**Quirksinger
 Laneway House**

ISSUED FOR	DATE
REZONING APPLICATION	2025-02-12
REV #	DESCRIPTION

CNV Staff Comment	Design change requested?	Design change required?	Smallworks Response	CNV Response
1 Land Use				
1.1 The maximum density according to the Residential Level One land use designation of the Official Community Plan and RS-1 Zoning is 0.5 FSR. The development including the Heritage house is 0.32 FSR which complies with the maximum permitted density.	No	No	N/A

Pre-Consultation Memo Response + Floor Plans

Elevations

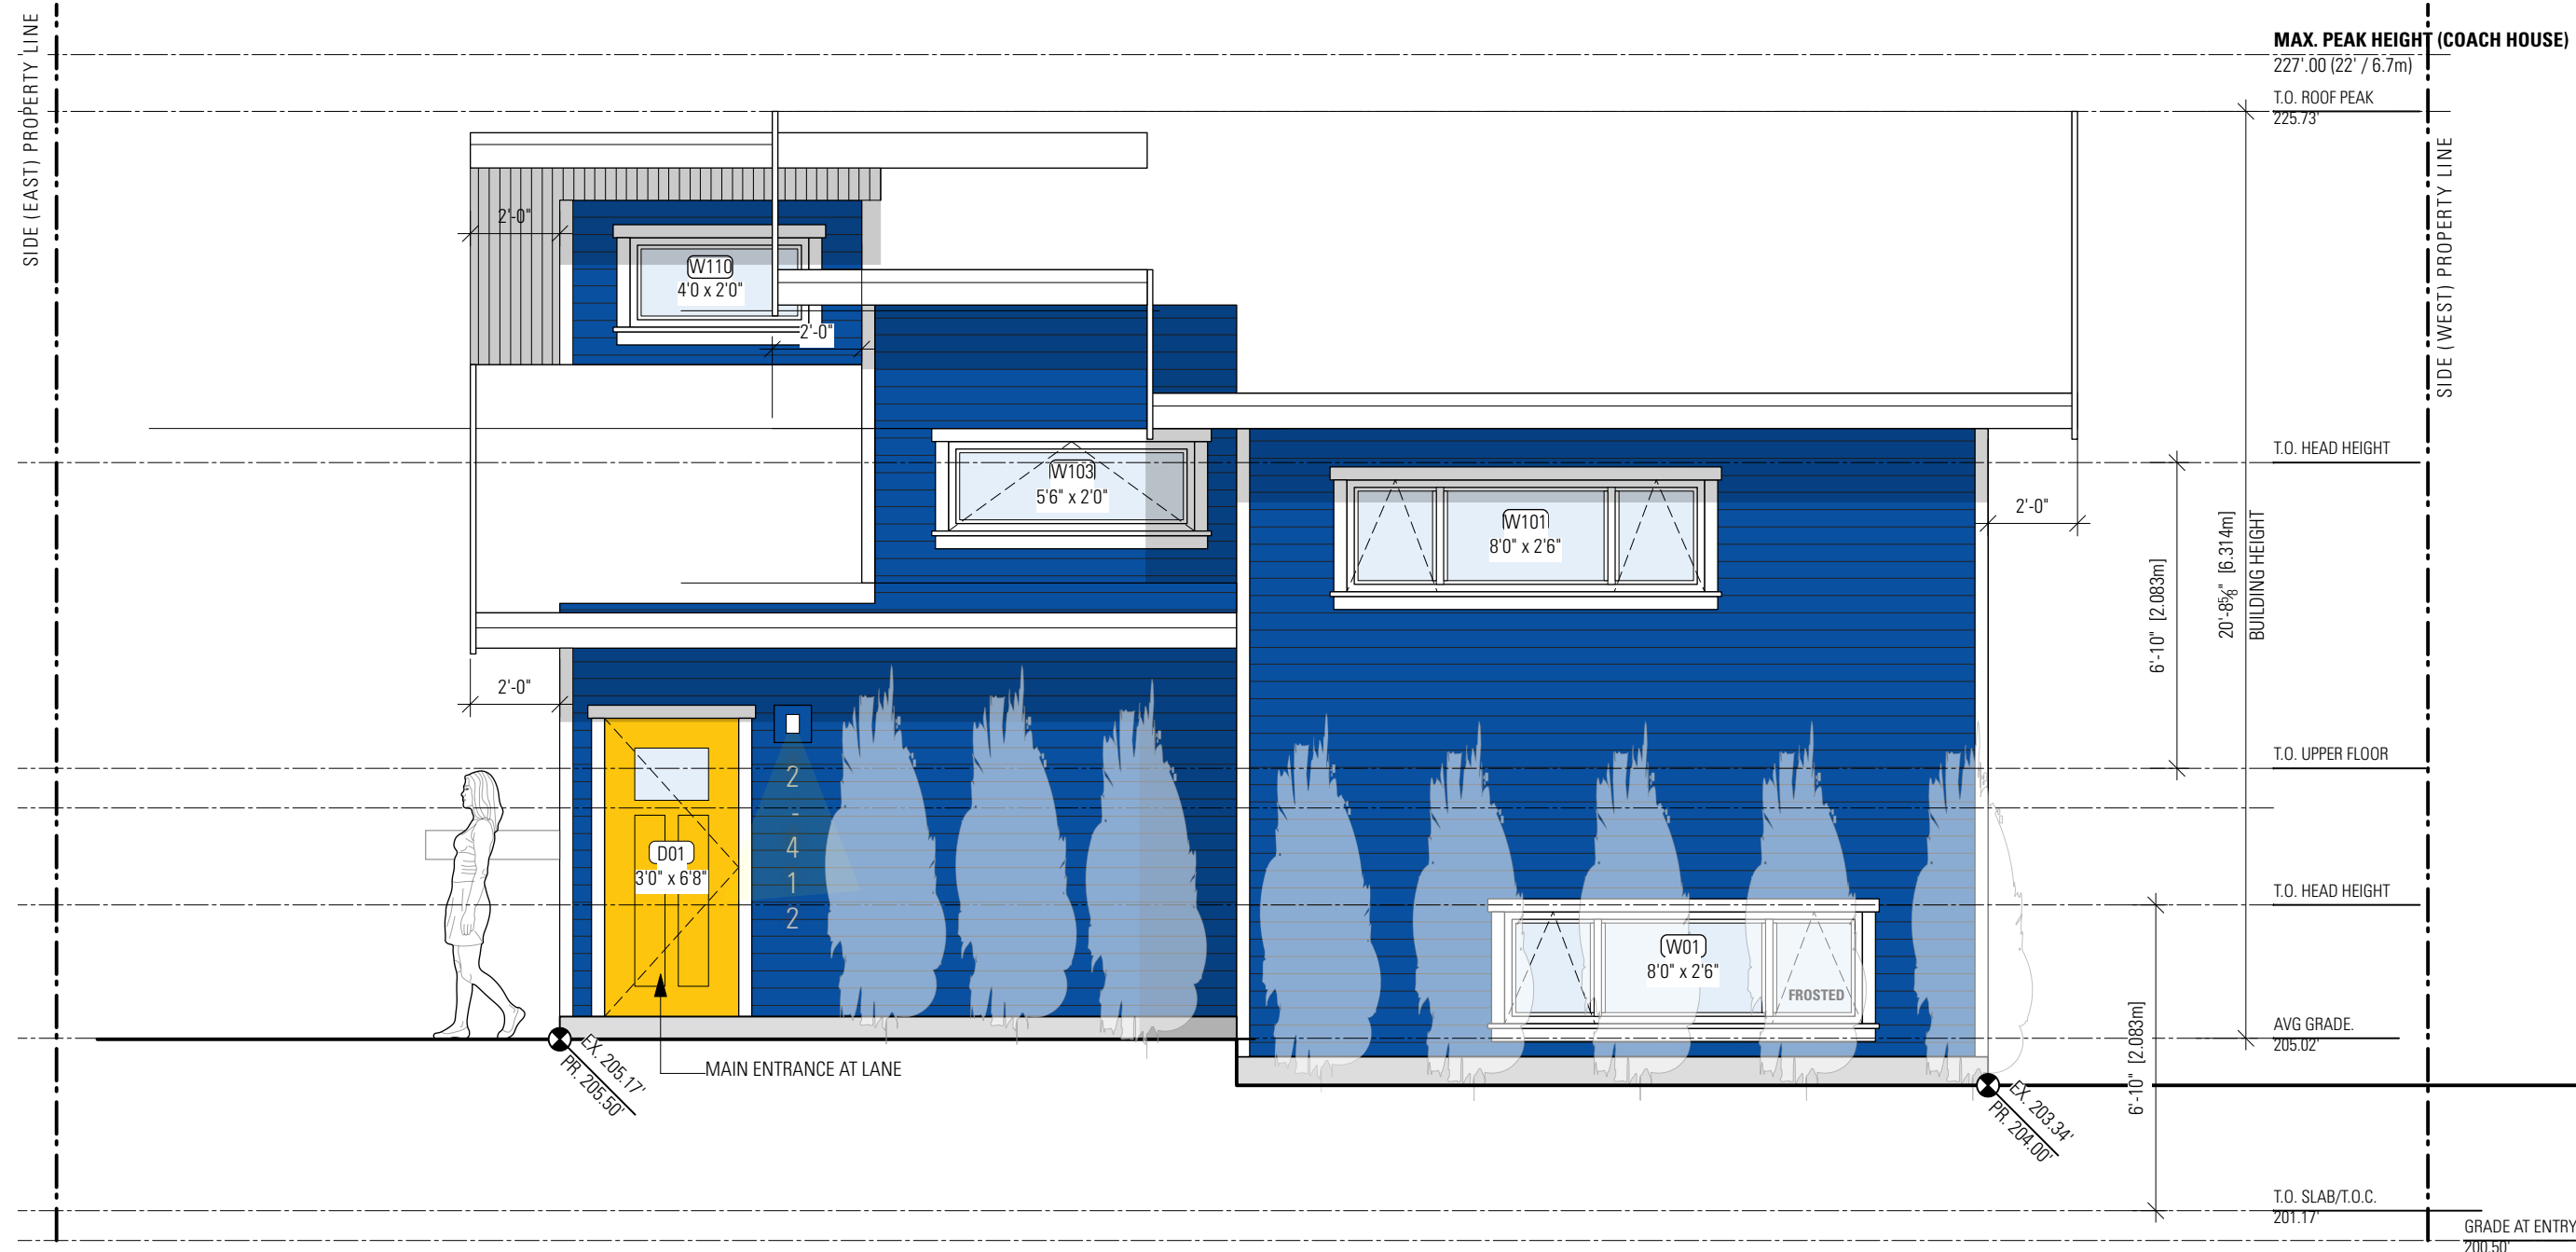
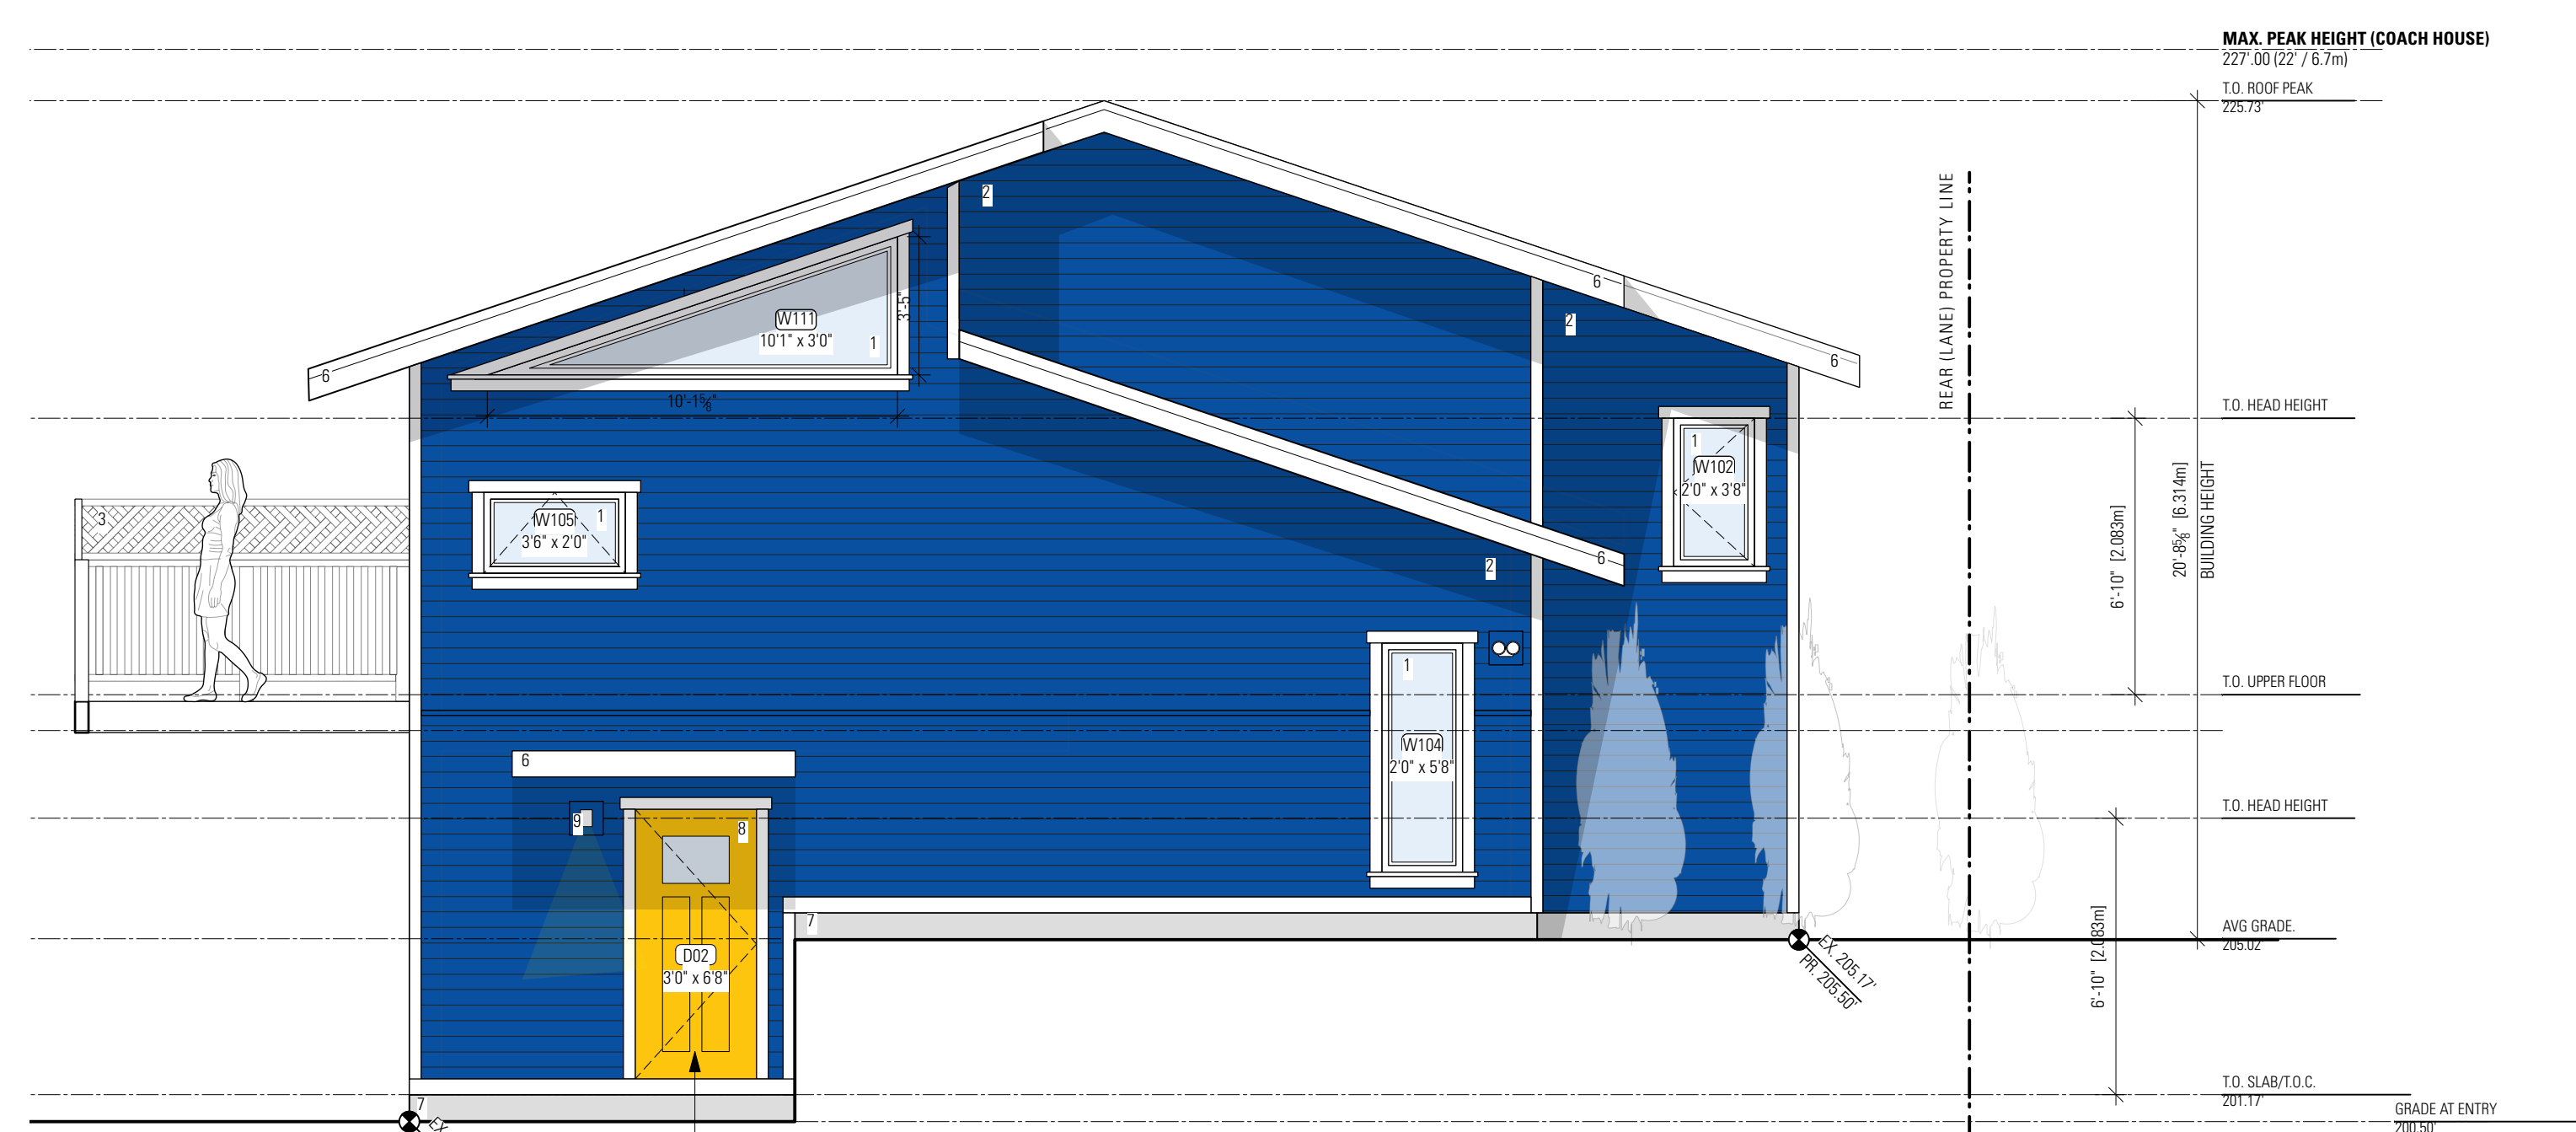
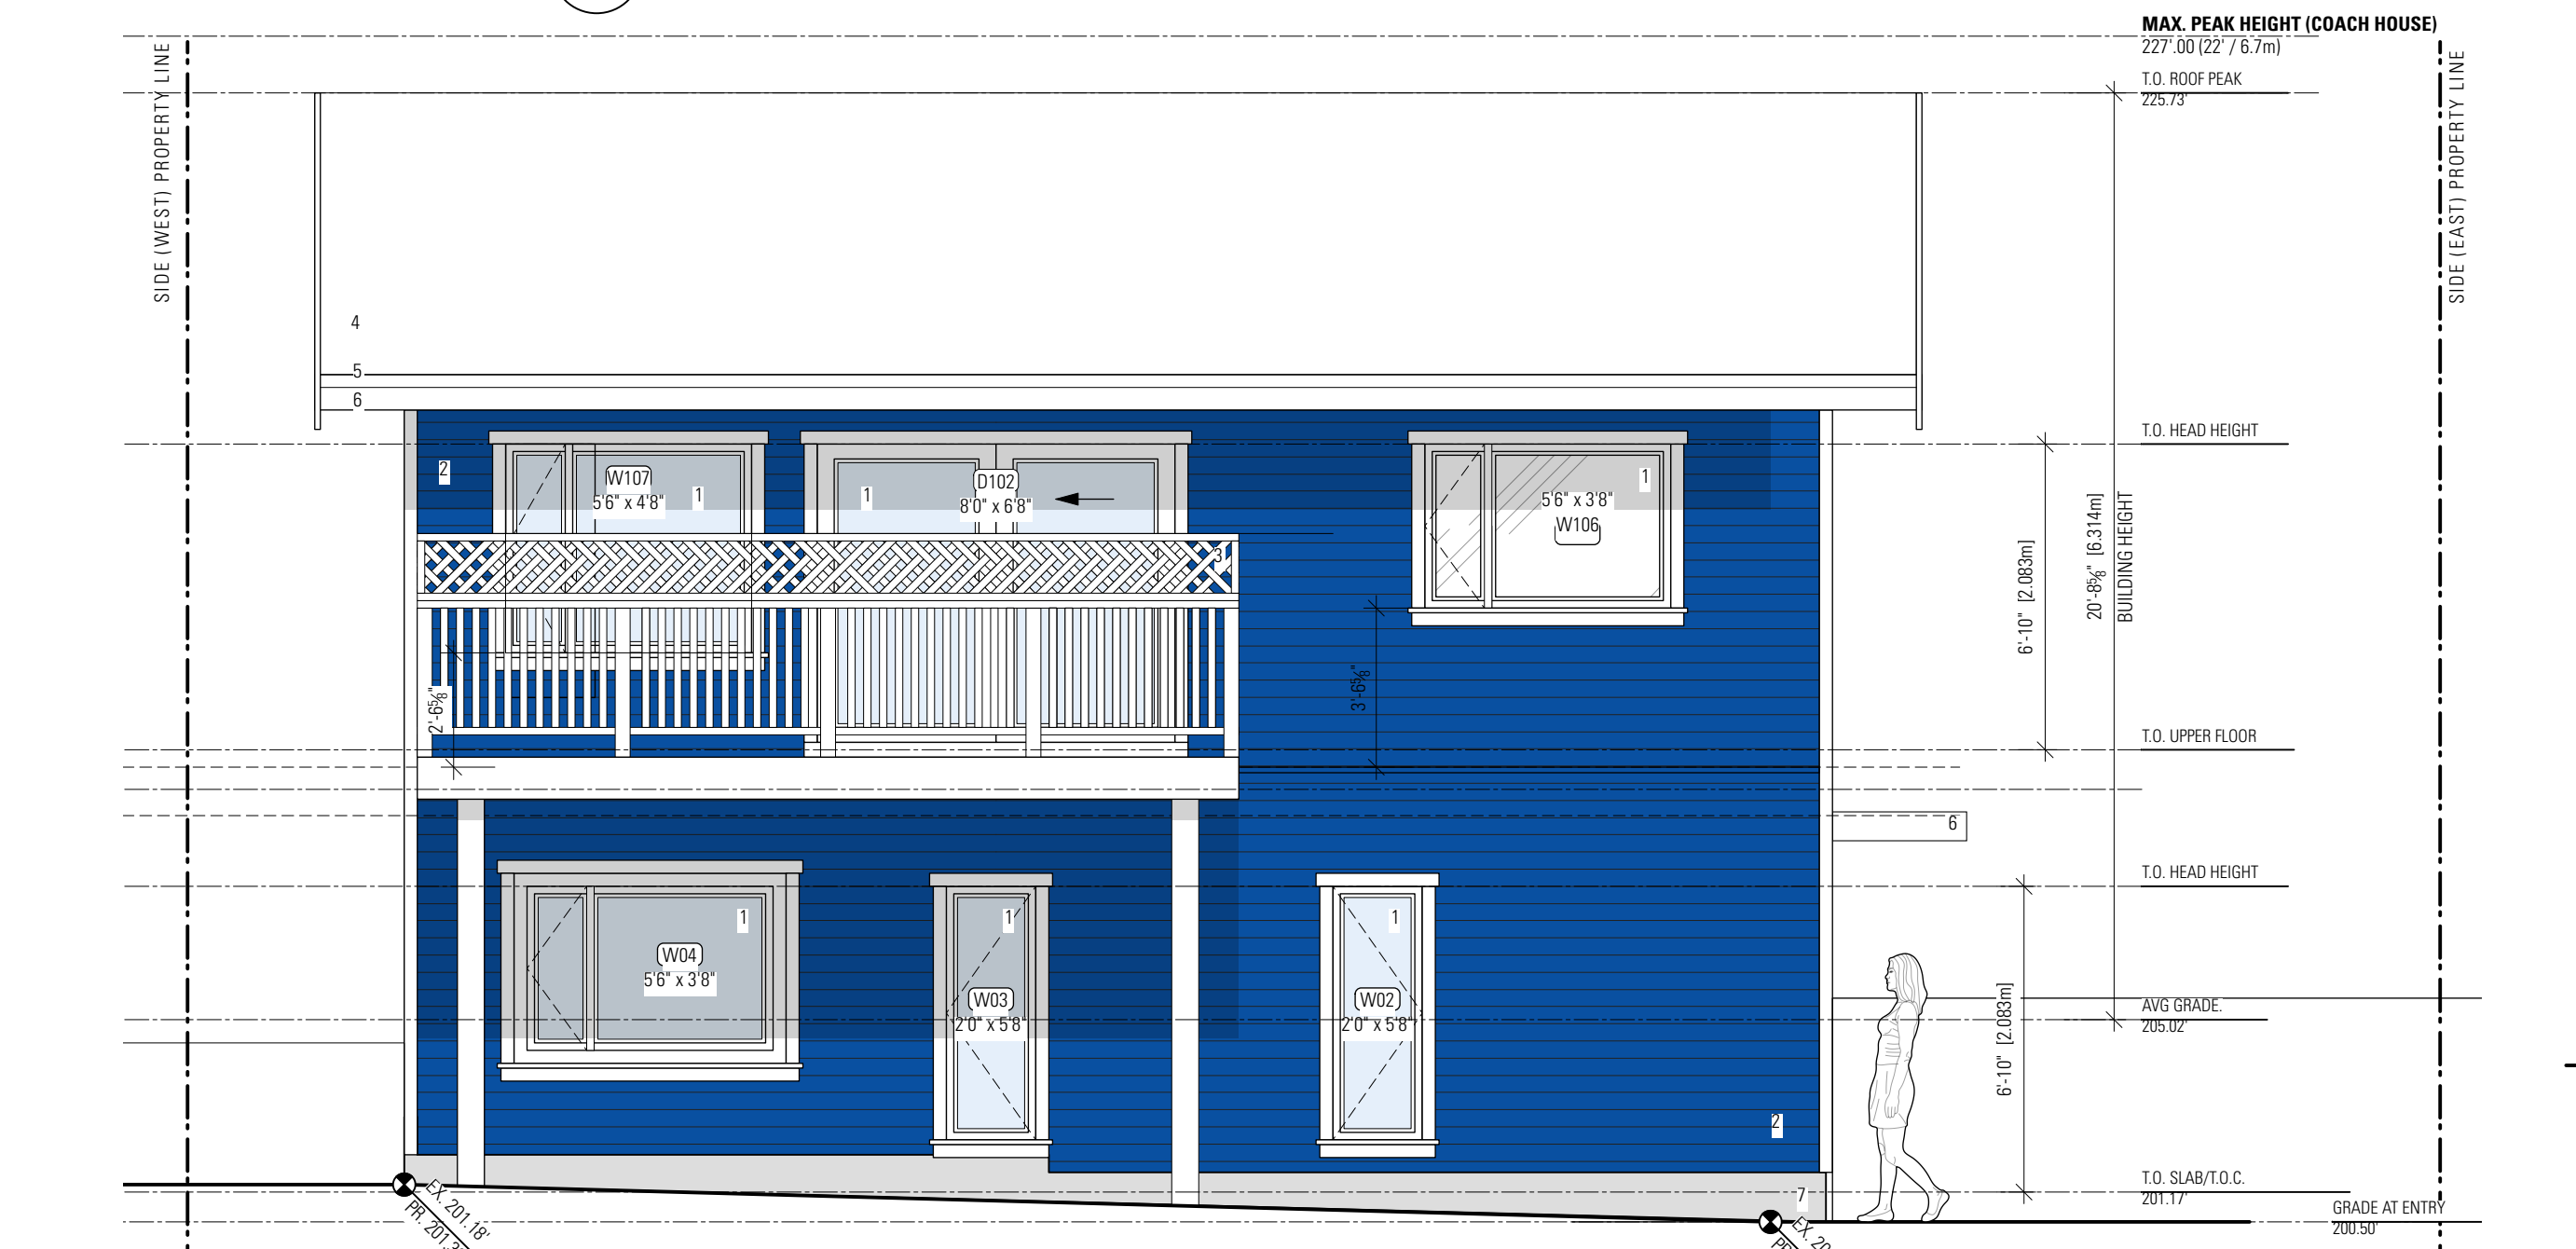
4.1 The coach house design would need to be contextual and complementary to the heritage home. This could be achieved through massing, proportions of windows and doors and material choice that references but do not copy the heritage home.	For consideration	No	The overall form and character of the proposed infill coach house is traditional -- respectful of, and in keeping with, the heritage home. It references the siding style of the heritage home with its horizontal lap siding, and its colours (blue siding with white trim) and complementary to those of the heritage home (white siding with blue trim). The roofing material has also been kept consistent between the two homes.	
5 General Planning Comments

5.4 The applicant must specify materials and colours of exterior finishes to be reviewed by the Heritage Advisory Committee.	For consideration	No	Materials and colours are specified on the proposed elevations
